INDESIT company

Model type:
LV460BK

Commercial code:
F030375

n1045085: Introduction of new litre counter turbine integrated on air-break.

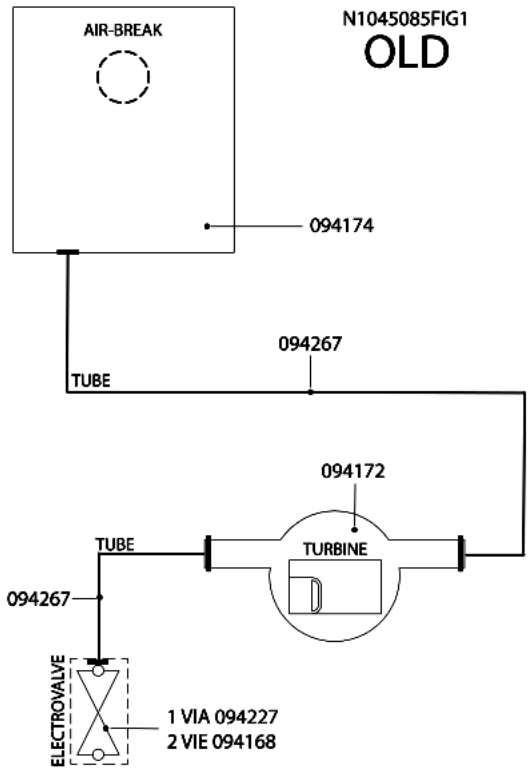
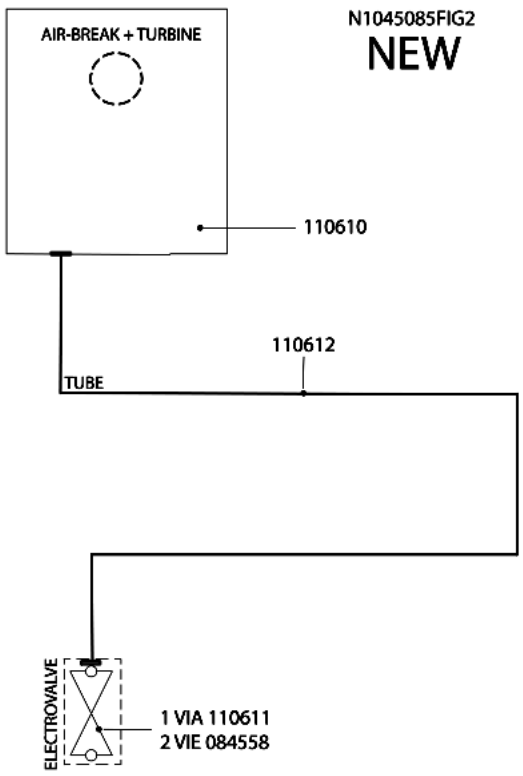
All dishwashers affected by this note have been equipped with a new litre counter turbine on the air-break.
Picture N1045085FIG1 illustrates the premodification structure, picture N1045085FIG2 the new structure.

AIR-BREAK:
new 110610;
premodification 094174;
the new item features a new integrated litre counter turbine and its water supply hose has a smaller diameter.

LITRE COUNTER TURBINE code 094172 has been eliminated.

SOLENOID VALVES:
new:
1-WAY code 110611;
2-WAY code 084558(Rohs 143737);
premodification:
1-WAY code 094227;
2-WAY code 094168;
the new solenoid valves have a smaller diameter drain hose fitting.

HOSES:
new solenoid valve hose/air-break code 110612;
premodification turbine hose/air-break code 094267;
premodification solenoid valve hose/air-break code 094267;
the new hose has a smaller internal diameter.

WIRING:
the litre counter turbine connecting cable is longer, but since the connector is the same, the new item can be used in place of the premodification one.

n1045087: Introduction of recessed heating element.

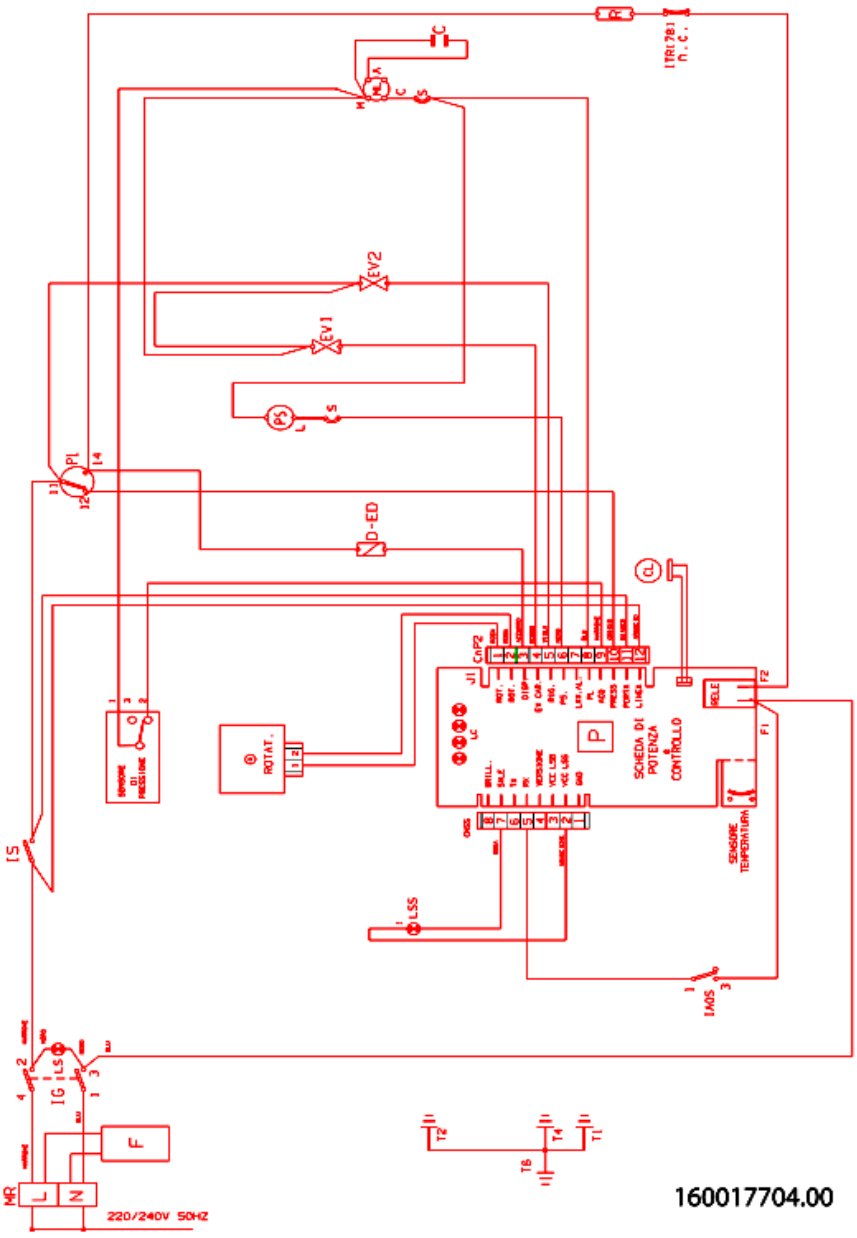
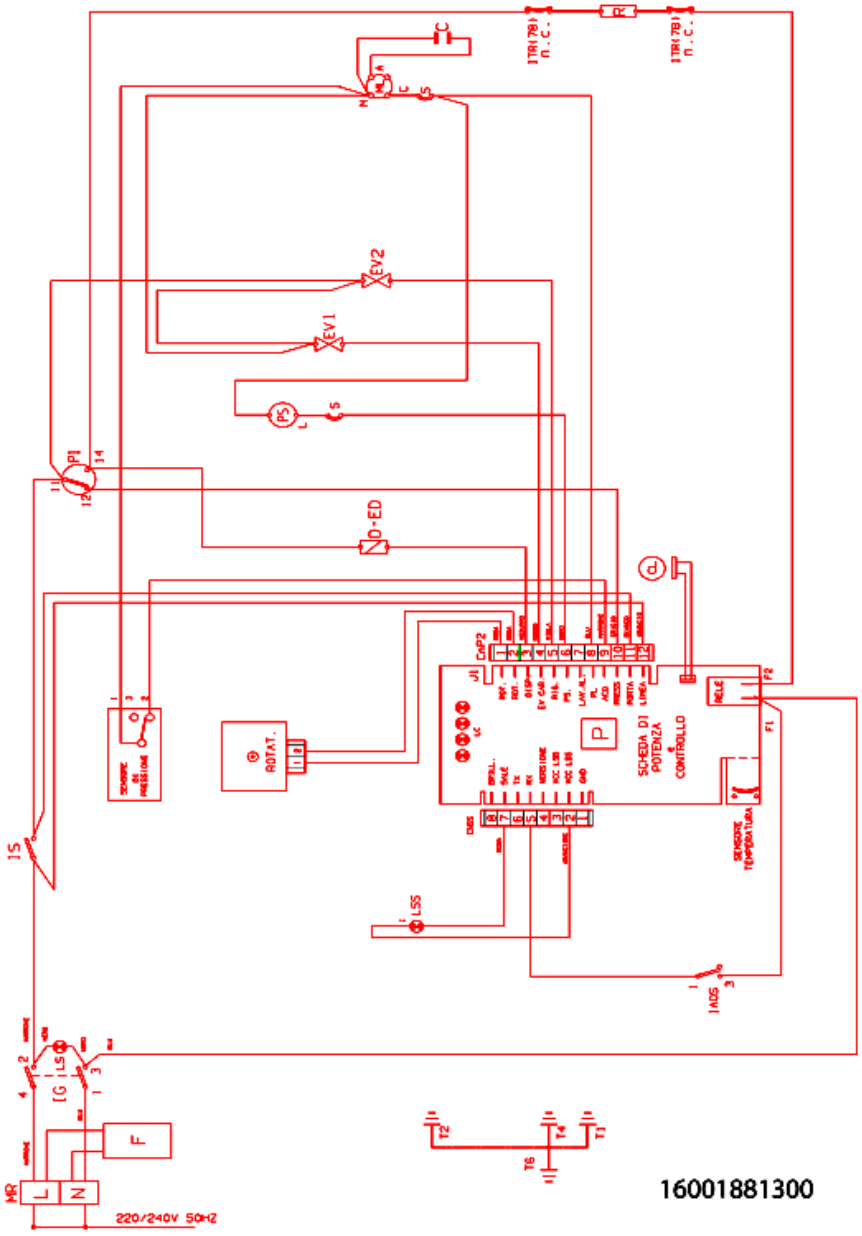
From serial no. 40624.0001, all dishwashers affected by this note have been equipped with a recessed heating element in place of the exposed one located inside the tank.
Given below are the codes of the items concerned:

ELIMINATED ITEMS:
nut + washer code 097871
o-ring seal code 063792
temperature probe code 063791
safety thermostat code 041086
exposed heating element code 066602
heater terminal protection code 074714
upper impeller supply tube code 056001
electrical pump connection tube - upper impeller supply tube code 076233
heater bracket code 054872

INTRODUCED ITEMS:
recessed heating element code 074000
upper impeller supply tube code 094152
heater coupling support code 078394
electrical pump connection tube - heating element code 057710

LV460BK (comm. code 30375)
Wiring Diagram: premodification 16001770400 new 16001881300
Wiring: premodification 110376 new 112487
